Safety Recall

N252533321 Stabilizer Bar Bracket Fracture

Release Date: November 2025

Revision: 00

7026943

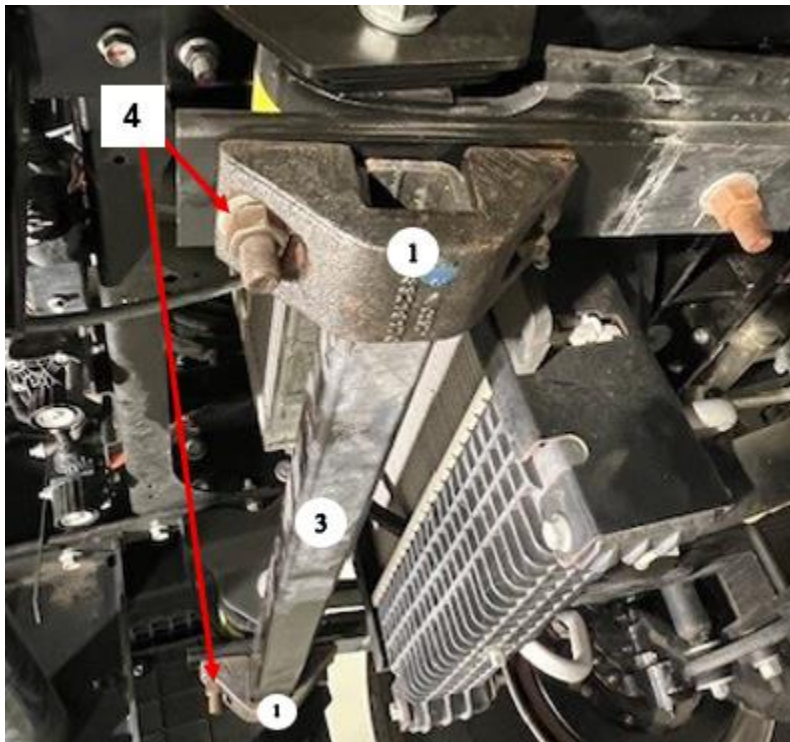
2. Remove the stabilizer bar mount brackets (1), rearward nuts, and washers (2).

7026948

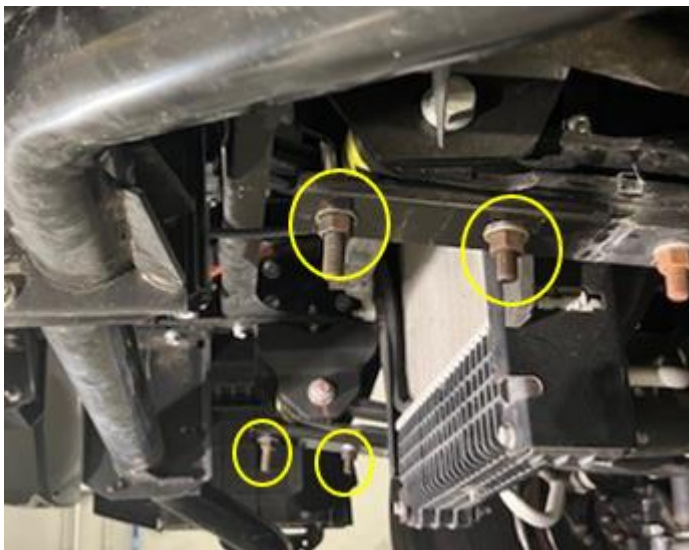
3. While supporting the stabilizer bar *3(remove the stabilizer bar mount brackets (1) forward nuts and washers (4) and remove the stabilizer bar and brackets.

4. Clean the mounting studs to remove any debris and excess penetrating oil applied in step 1.
5. Reinstall the old washers and nuts on each of the four stabilizer bar bracket studs and hand tighten.
6. Tighten all four nuts and torque to 170 lb-ft (240 N-m).
